T02: Reason for Moving: This move is a value engineering opportunity that positively impacts site disturbance. The turbine is moved slightly south, with the hardstand rotated, resulting in a reduction of required site tracks.

Figure 2.1b
Infrastructure Design Review
- Turbine 02

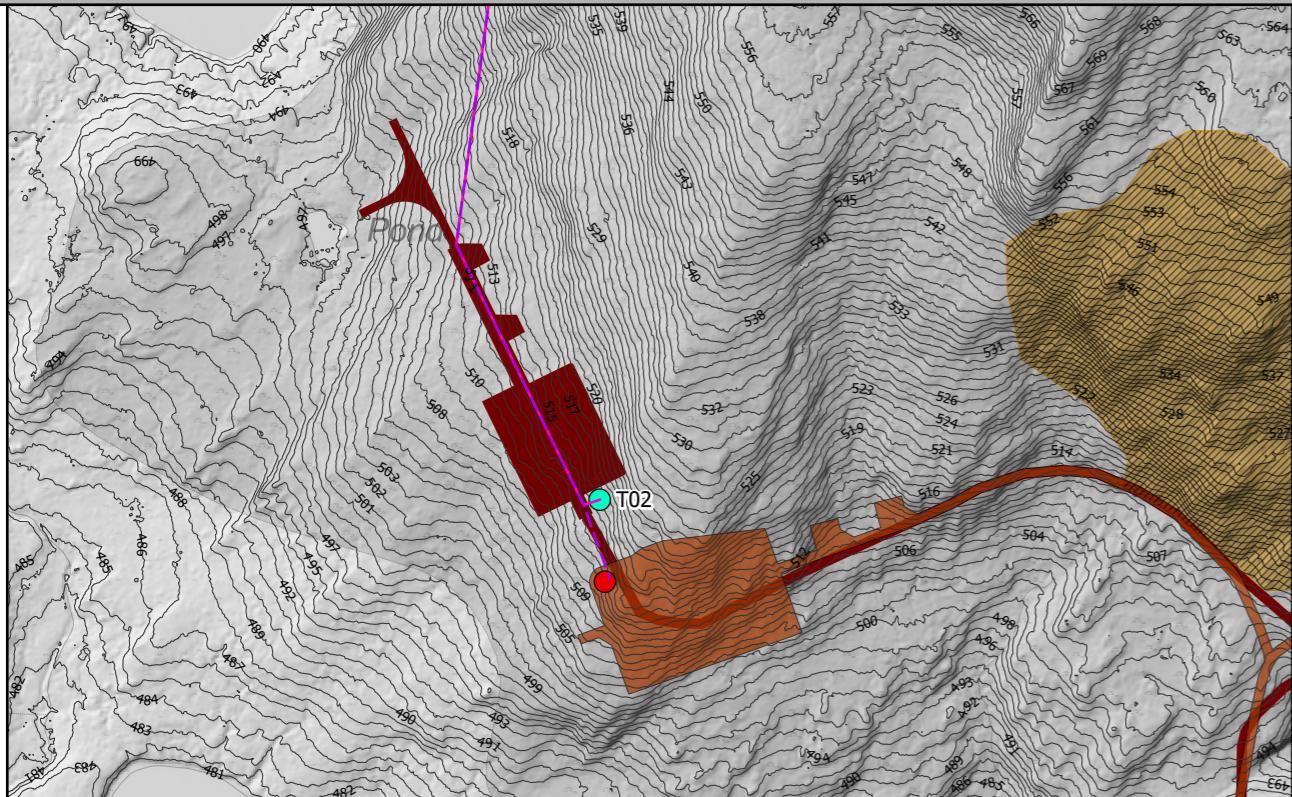
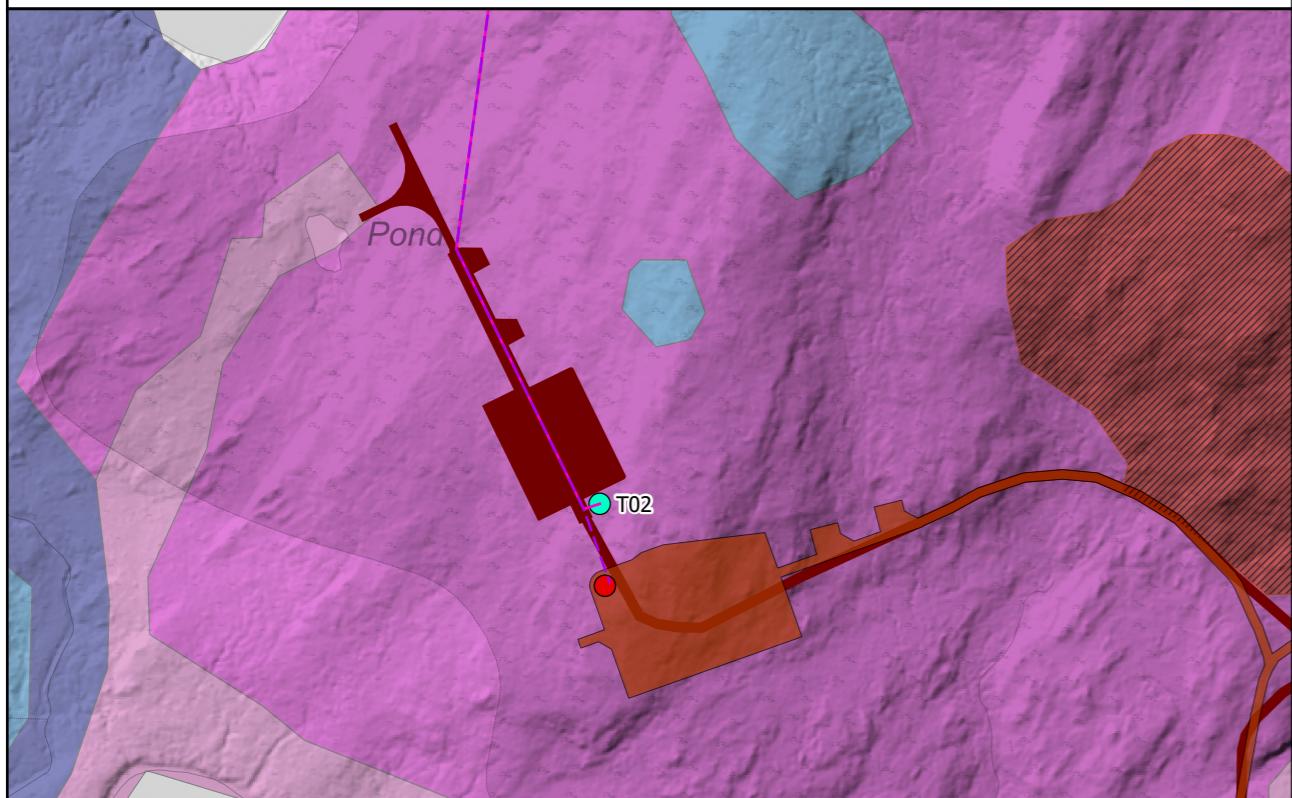
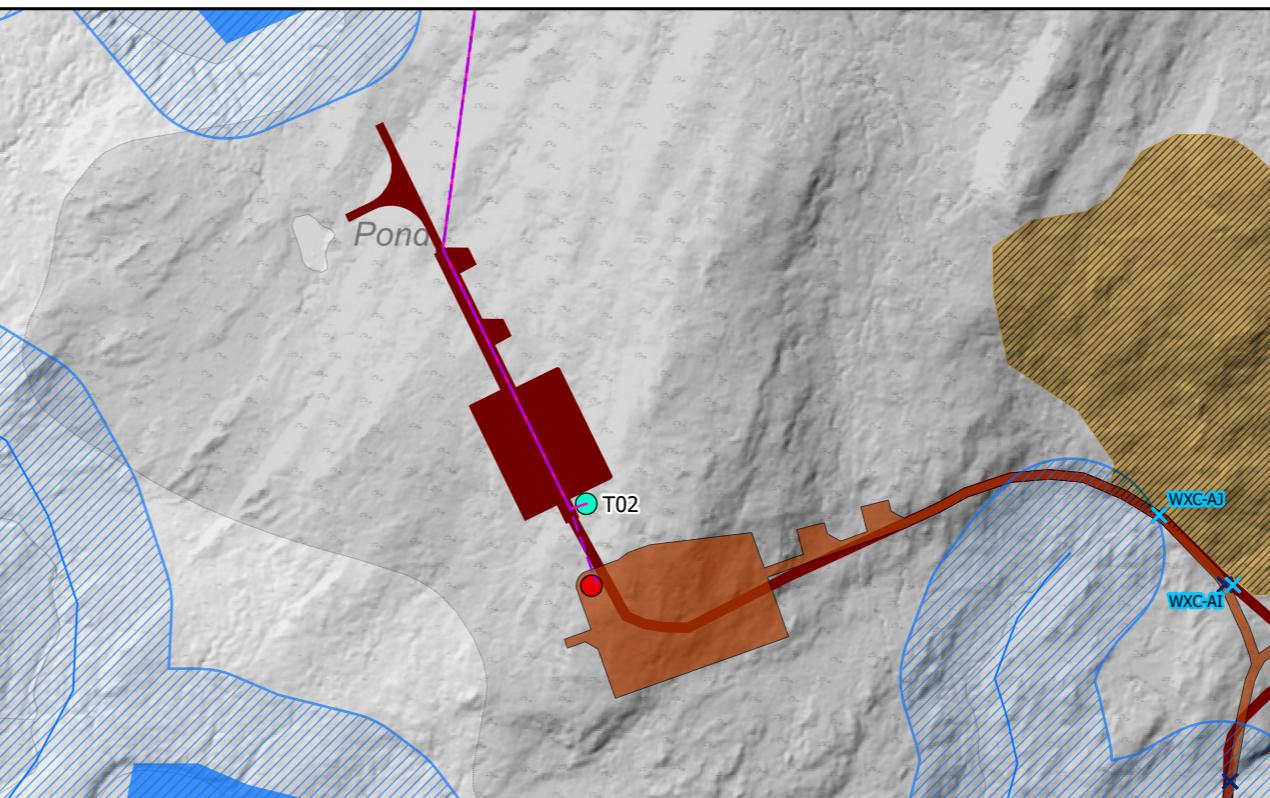
Engineering: The rotated hardstand position will achieve (as far as feasible) a balance between cut-fill on this spur. The new turning head has been positioned to extend into a relatively flat area of ground to the south of the spur. The access gradient to the spur has been checked for suitability against the WTG supplier's track requirements.

Geology Impacts: Rotating the hardstand approximately 90 degrees clockwise aligns it with the track spur off the main spine road, eliminating the need for the track extending northeast from the turbine location. This reduces the track length by approximately 260m. The new hardstand location is within the allowable micrositing limit of the consented track leading to the turbine base. The proposed turbine location is within the 50m micrositing limit from the current consented position.

Ecology Impacts: The overall disturbed area is reduced by removing 260m of track and a turning head. All infrastructure remains within the same NVC survey habitat type (M15c). An area of M17c is preserved by removing the turning head north of the consented track.

Hydrology Impacts: Reducing the northeast track and removing the turning head near the watercourse buffer minimizes impact on the lochan to the north. Although the consented track does not enter the watercourse buffer, construction activities in this area would have had some impact, which is now avoided.
